County of Fresno

Main Annex Jail
ADA Transition Plan

LARS ANDERSEN & ASSOCIATES, INC.

JUNE 30, 2014

314	Main Annex Jail	**Priority:**	2
Category	Detention Facility Showers

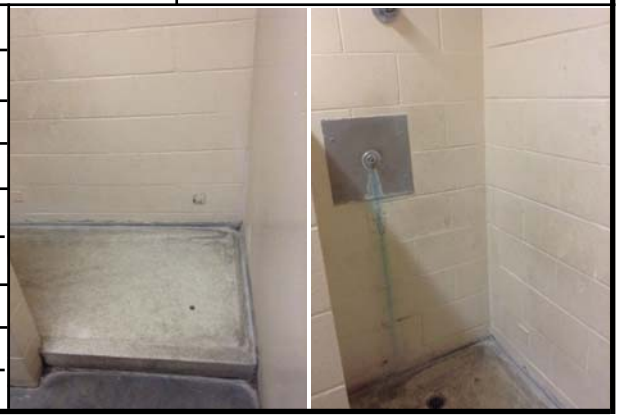
ADA Reference:	
608.7	
CBC Reference:	
11B-608.7	
Floor:	1st
Room:	male dress-in
Location:	Shower
Cost:	2000
Duration:	20 hrs

315	Main Annex Jail	**Priority:**	2
Category	Detention Facility Showers

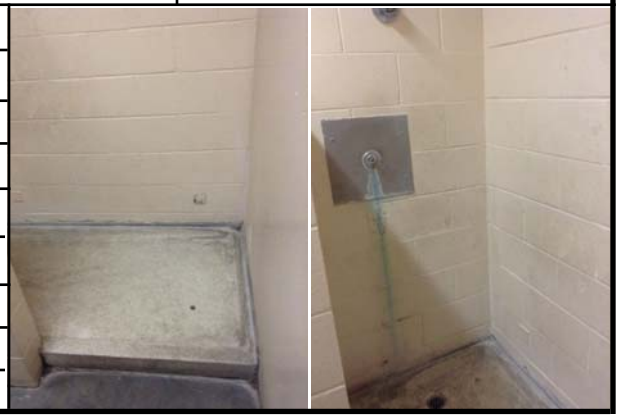
ADA Reference:	
N/A	
CBC Reference:	
11B-610.5	
Floor:	1st
Room:	male dress-in
Location:	Shower
Cost:	800
Duration:	1 hr

994	Main Annex Jail	**Priority:**	2
Category	Detention Facility Showers

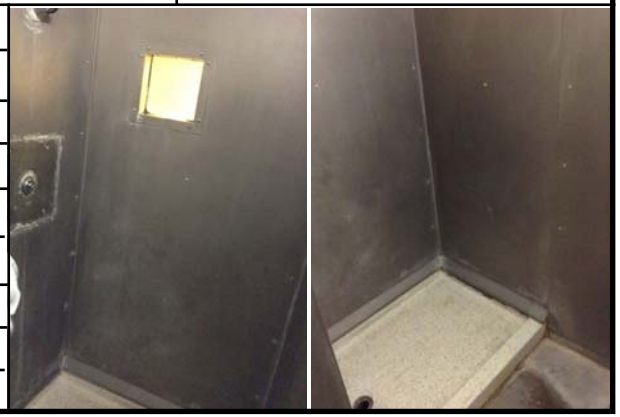
ADA Reference:	
N/A	
CBC Reference:	
11B-610.5	
Floor:	3rd
Room:	Shower
Location:	Rear Cell
Cost:	See *11
Duration:	See *11

995	Main Annex Jail	**Priority:**	2
Category	Detention Facility Showers

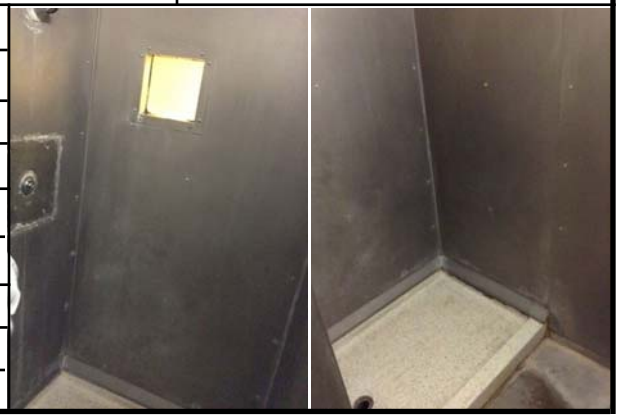
ADA Reference:	
608.3.2	
CBC Reference:	
11B-608.3.2	
Floor:	3rd
Room:	Shower
Location:	Rear Cell
Cost:	See *11
Duration:	See *11

997	Main Annex Jail	**Priority:**	2
Category	Detention Facility Accessories

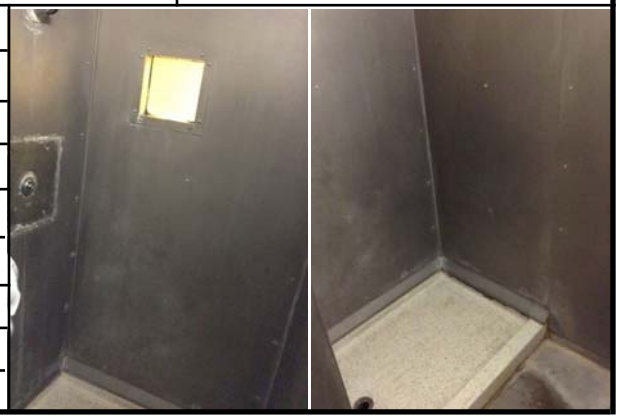
ADA Reference:	
608.3.2	
CBC Reference:	
11B-608.3.2	
Floor:	3rd
Room:	Shower
Location:	Rear Cell
Cost:	See *11
Duration:	See *11

1056	Main Annex Jail	**Priority:**	3
Category	Accessories

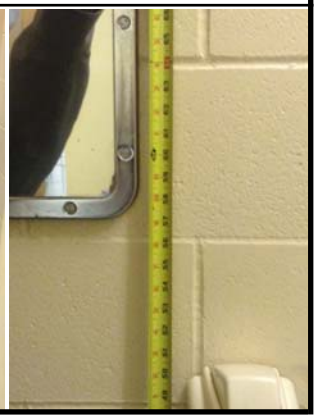
ADA Reference:	
603.3	
CBC Reference:	
11B-603.3	
Floor:	3rd
Room:	Infirmary
Location:	Restroom
Cost:	100
Duration:	1 hr

1057	Main Annex Jail	**Priority:**	3
Category	Lavatories (GENERAL)

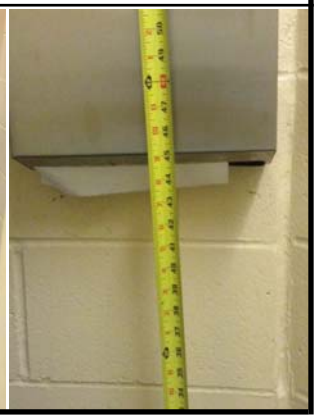
ADA Reference:	
N/A	
CBC Reference:	
11B-603.5	
Floor:	3rd
Room:	Infirmary
Location:	Restroom
Cost:	50
Duration:	.5 hrs
